London Road Fire Station

Issue 01

**DESIGN & ACCESS STATEMENT FOR UPDATED LAYOUTS
AND HERITAGE ASSESSMENT**

COMPARATIVE PLANS – SECOND FLOOR LEVEL

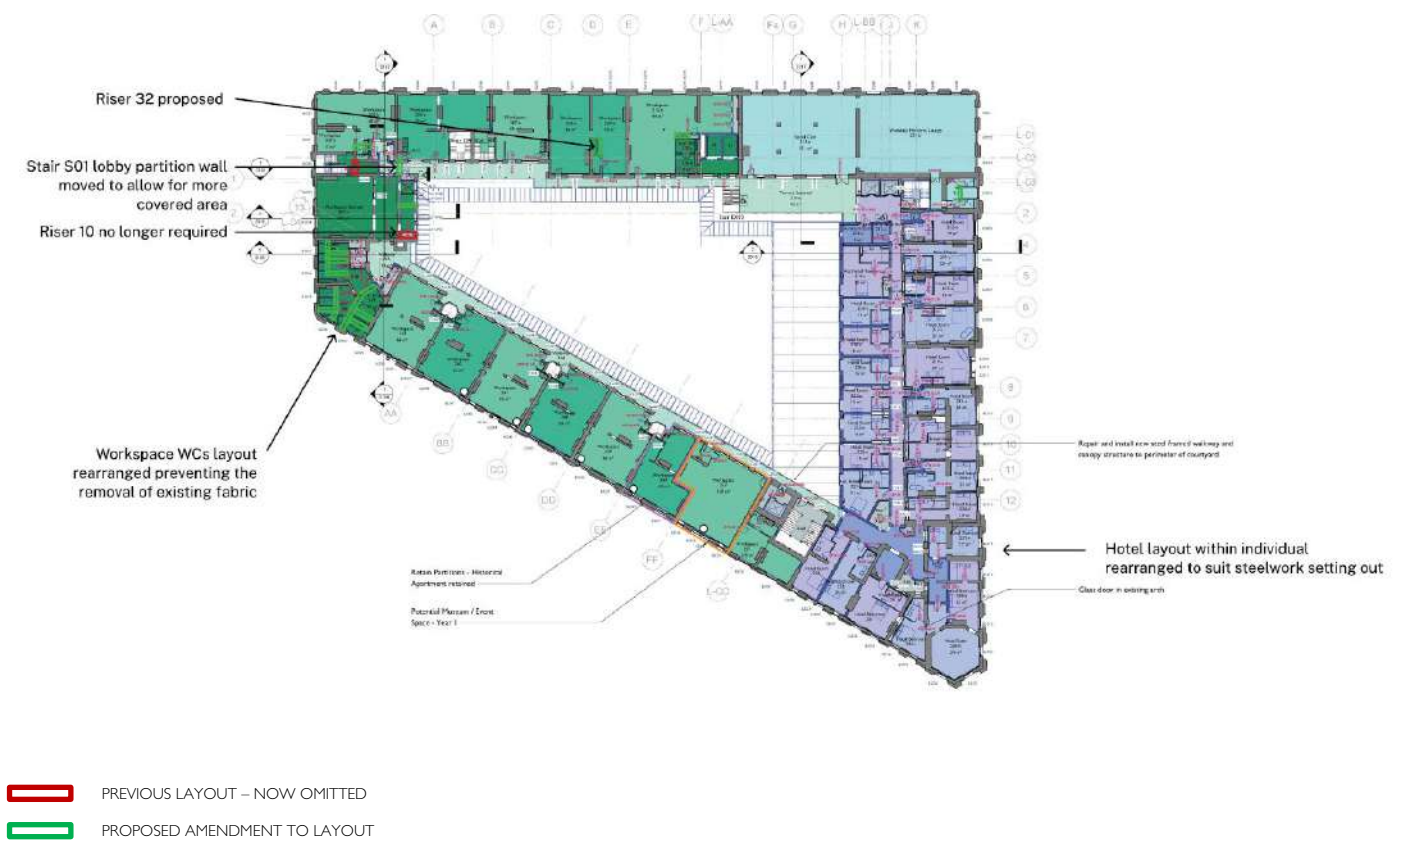
- Stair S10 lobby partition wall moved from proposed position to create more covered area.
- Riser 10 now omitted as this is required to GF only as part of revised MEP strategy, so removal of historic fabric omitted from the proposals in this area.
- Workspace WC Layouts amended to retain existing windows and daylight to these areas.

- Hotel room layouts amended following feedback from operator. Changes have arisen for various reasons, for example changes to the hotel layout due to steelwork positions.

- Riser 32 included as part of new vertical riser strategy.

Figure 3.1e – Third Floor Layout: **Above:** Consented scheme comparison and **Below:** Proposed GA plan

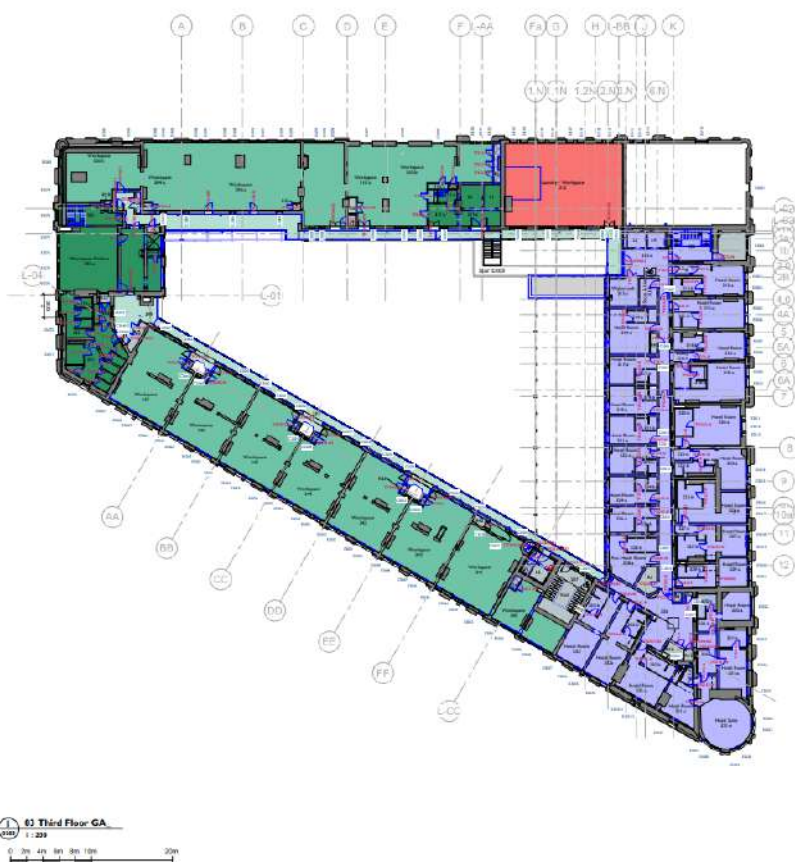
- Stair S10 lobby partition wall moved from proposed position to create more covered area.
- Riser 10 now omitted as this is required to GF only as part of revised MEP strategy, so removal of historic fabric omitted from the proposals in this area.
- Workspace WC Layouts amended to retain existing windows and daylight to these areas.

- Hotel room layouts amended following feedback from operator. Changes have arisen for various reasons, for example changes to the hotel layout due to steelwork positions.
- Lift Lobby Walls amended from proposed position.
- Stair S11 omitted as roof terrace is no longer proposed, so no access required.

- Riser 32 included as part of new vertical riser strategy.

Figure 3.1f – Roof Layout: **Above:** Consented scheme comparison and **Below:** Proposed roof plan has been able to significantly reduce services penetrations through roof area via revised MEP Services Distribution strategy.

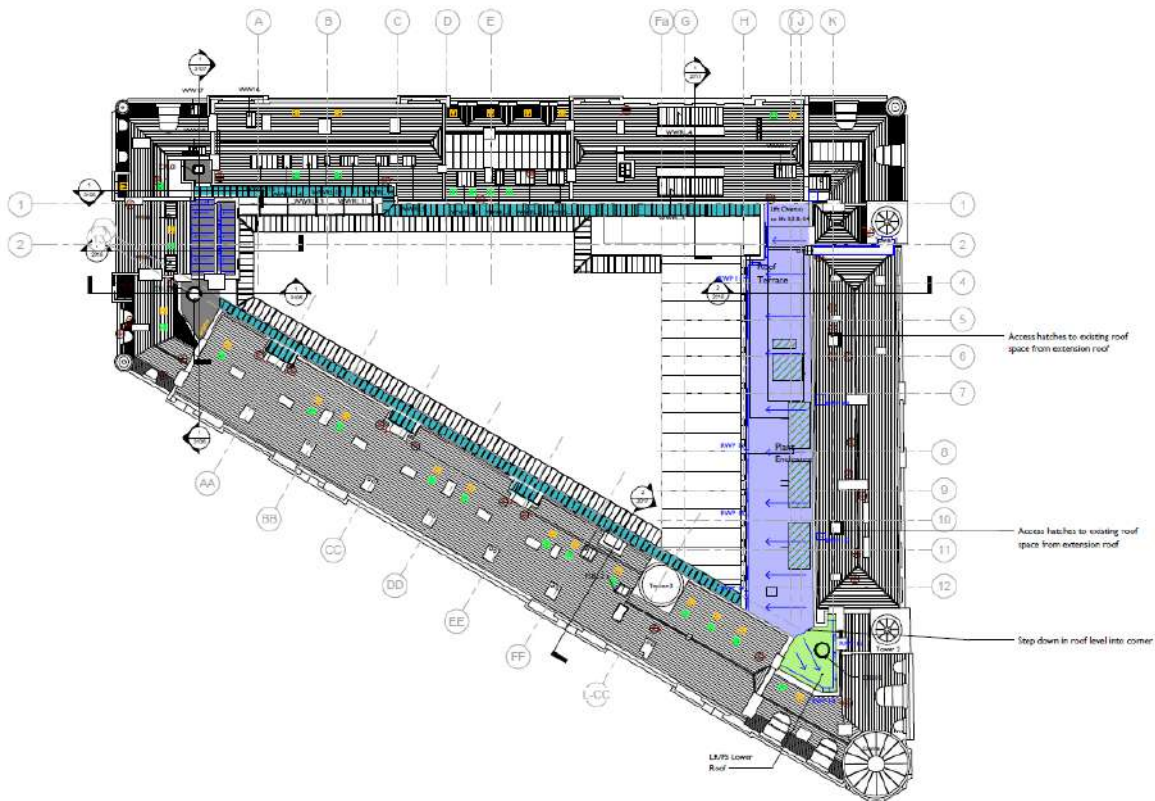
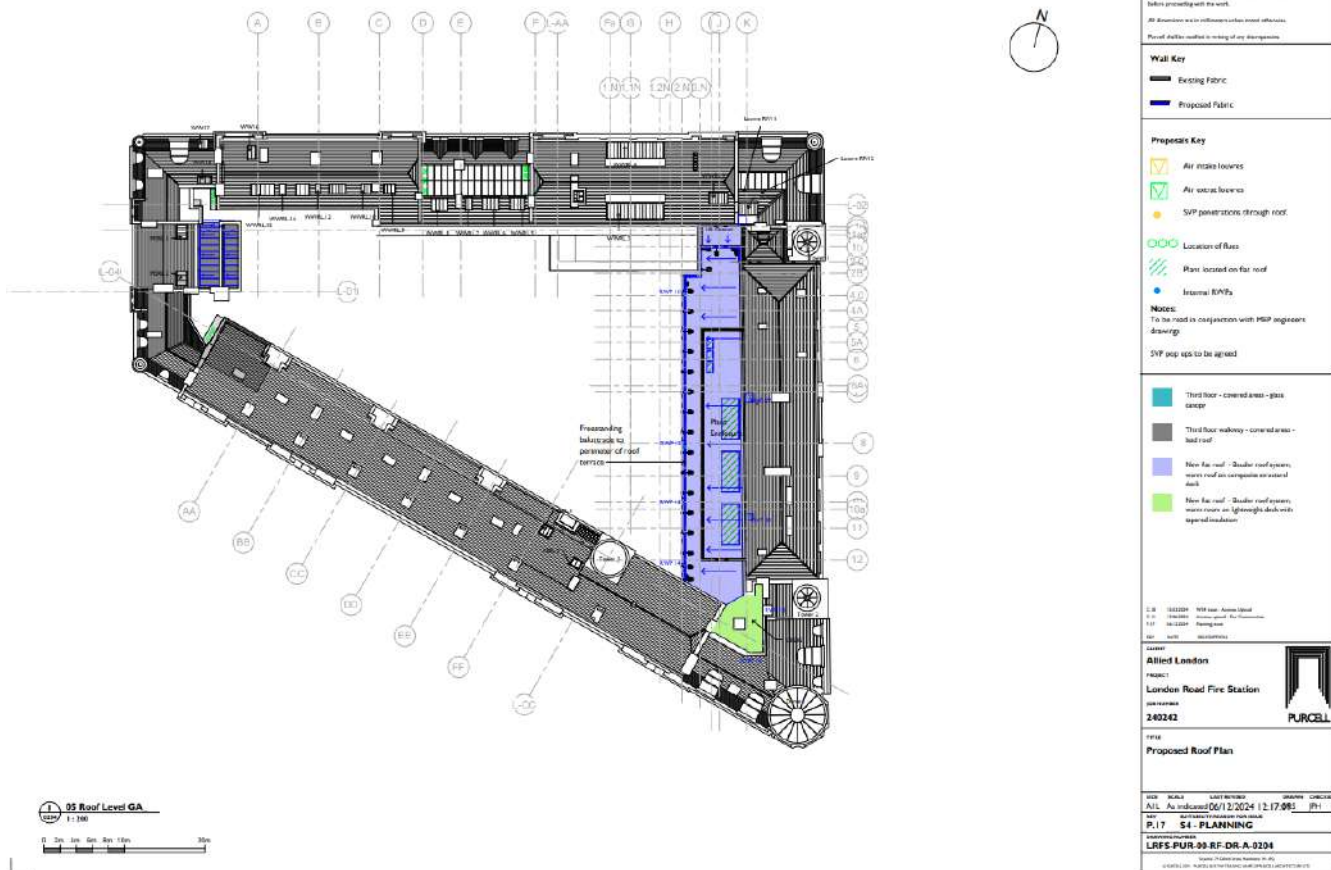
- The original roof plan had a roof terrace area access from a new stair from 3F. In addition to this, the MEP strategy required multiple penetrations through the pitched roof areas across the building.

- Stair S11 is proposed to be removed as the roof terrace has been omitted from the scheme, meaning that access to the roof for the general public is no longer required. The consented glass balustrading to roof level is to be replaced with a simple metal balustrade.

- The revised MEP Strategy includes strategically placed vertical risers to allow more concentrated distribution through the building and localised distribution of services to the Hotel and Workspaces. This has significantly reduced the number of penetrations through the pitched roof areas and allowed any penetrations to be situated in either the new build elements of the roof on the hotel plant deck, the area of flat lead roof above the workspaces on Whitworth St or within the flat roof areas of the new risers to the walkway perimeter

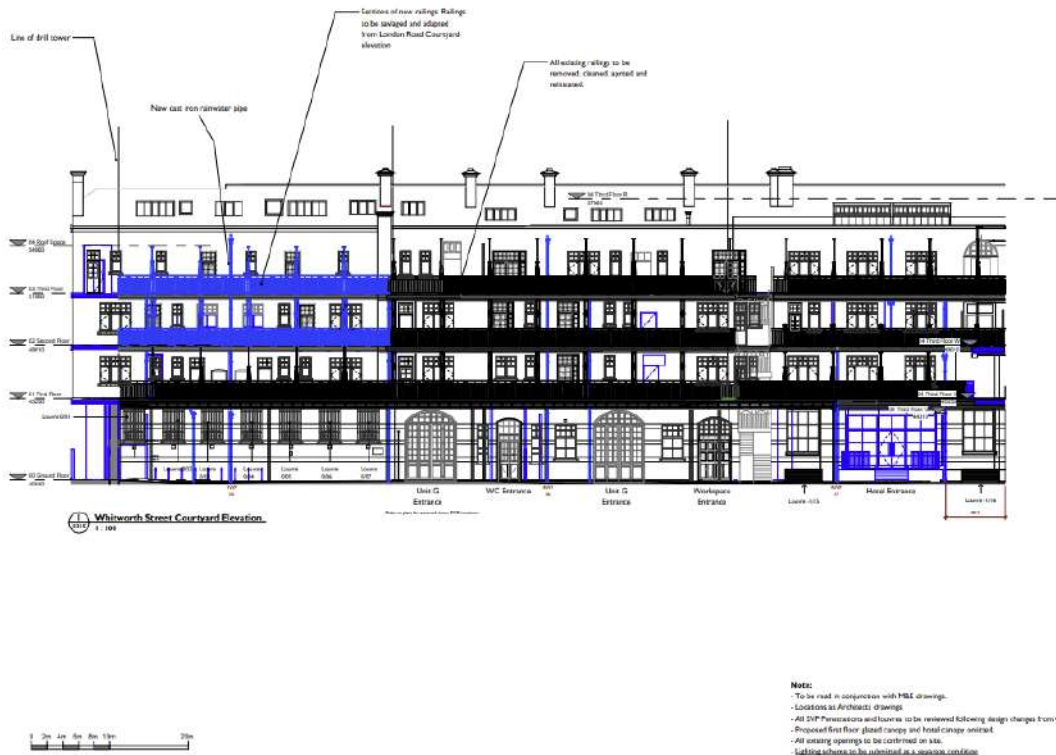
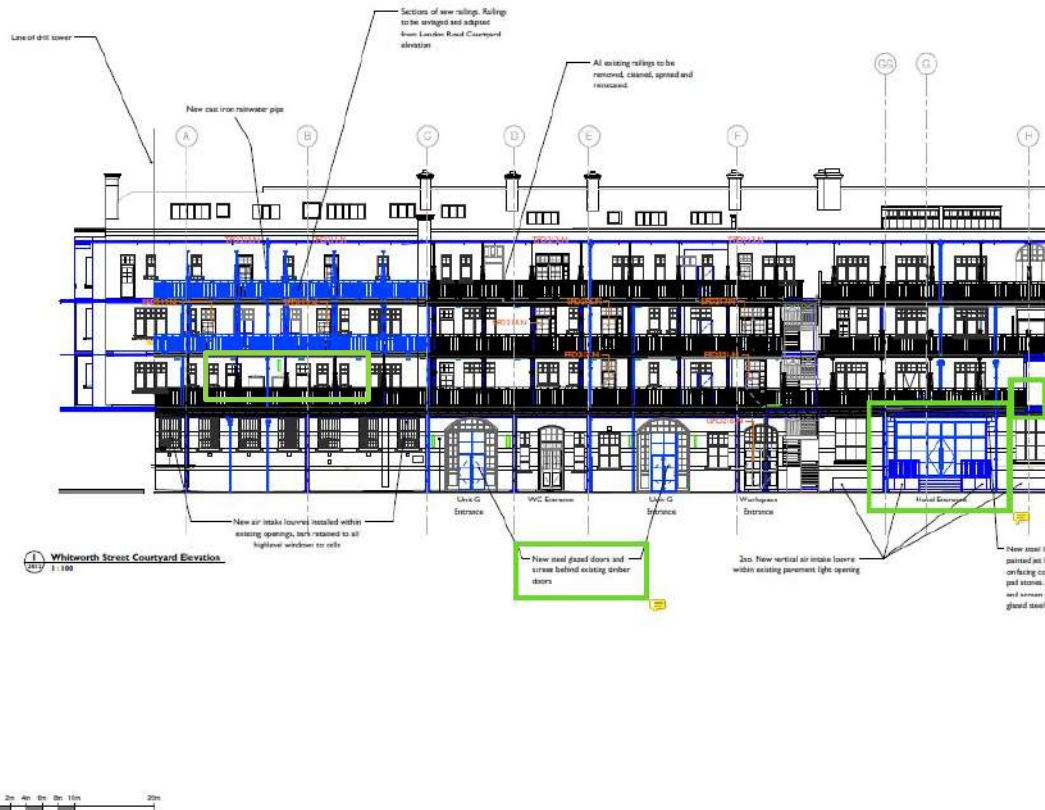
- Introduction of two external doors to the first-floor workspaces to Whitworth Street means that existing fabric on stairways can be retained and ensures compliance with the proposed fire strategy. These doors are proposed to former window opening positions.
- 2no. new glazed doors to be installed behind the existing timber doors,
- Omission of full glazed canopy to courtyard perimeter and inclusion of new canopy over the hotel entrance only
- Additional areas of balustrade to infill the open sections adjacent to the new hotel

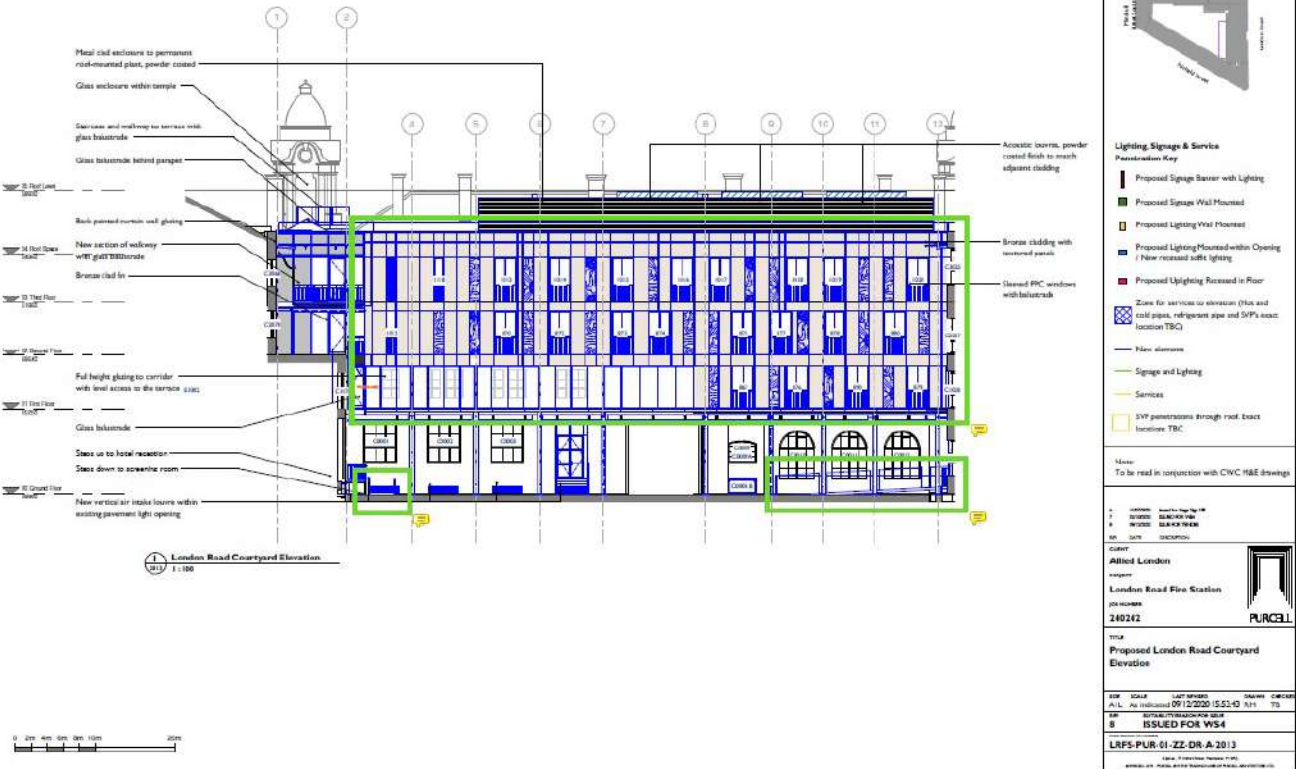
- Changes to hotel façade consented separately ref. 136104/FO/2023 & 136105/LO/2023.
- Omission of full glazed canopy to the perimeter of the façade
- Inclusion of new canopy over the hotel entrance only
- Omission of ramp to former Coroners Court and inclusion of lift and stairs.

Figure 3.2a – Retained External Stair, Design Intent

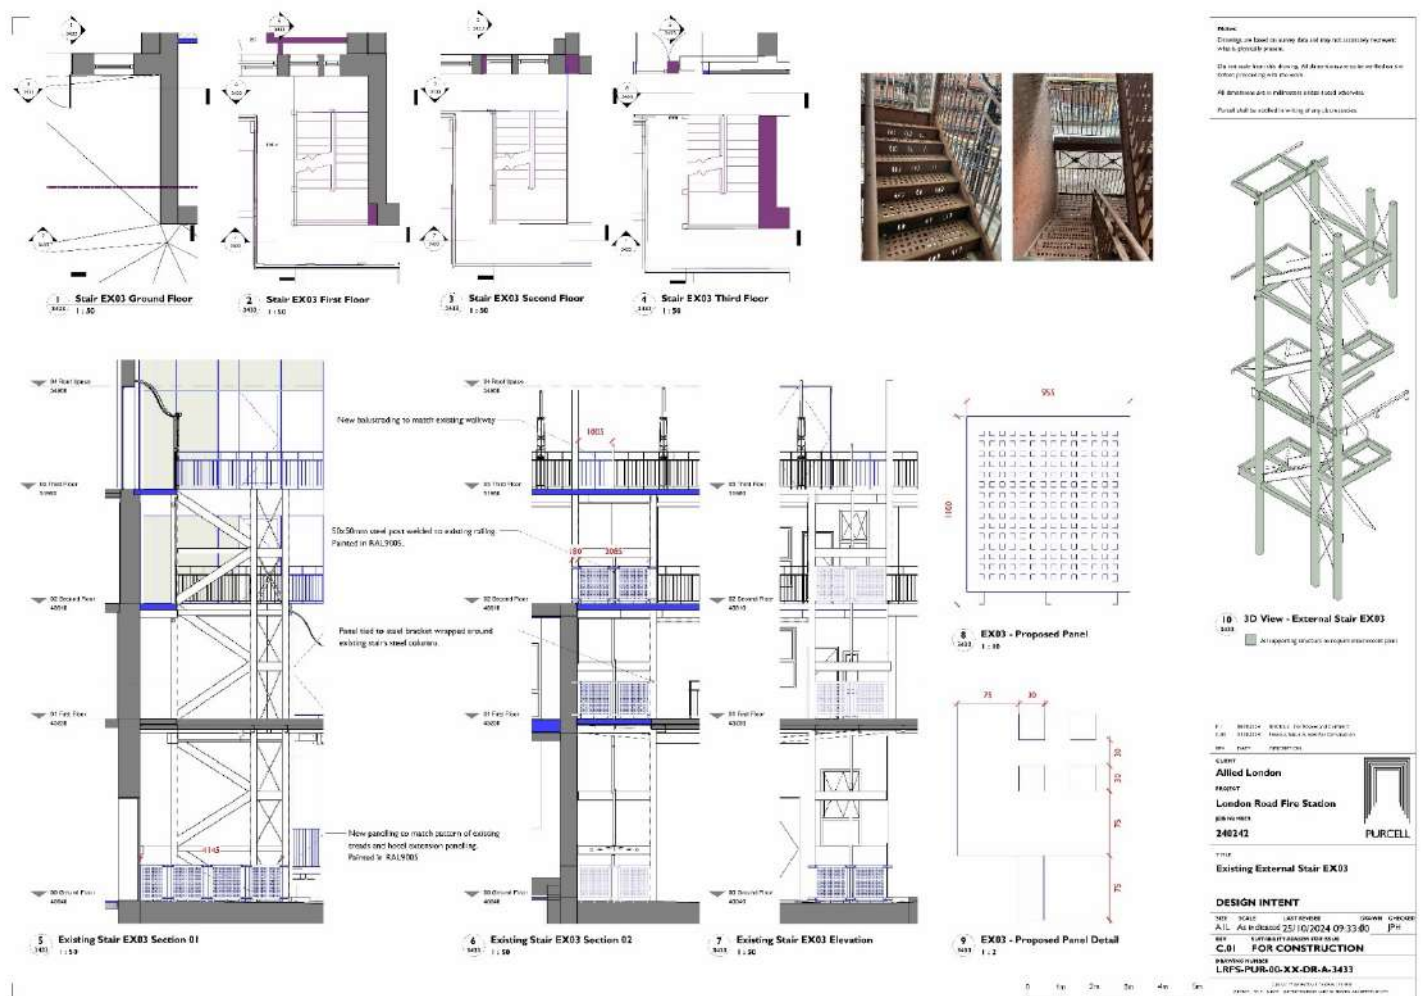
This element of the project originally formed part of the circulation and fire strategy. However, due to its condition, this is now proposed to be repaired and retained in situ but will not form part of the circulation or fire strategy, which have been redesigned to accommodate this omission.

It has been agreed that this forms part of the high significance of the wider courtyard area and its retention will have a continued moderate benefit to the scheme. A proposal has been included to provide fixed metal decorative panels, that are placed to the front of each flight, to the same height as the existing balustrade to prevent unintended access. The design of these references both the existing stair treads and new façade cladding pattern.
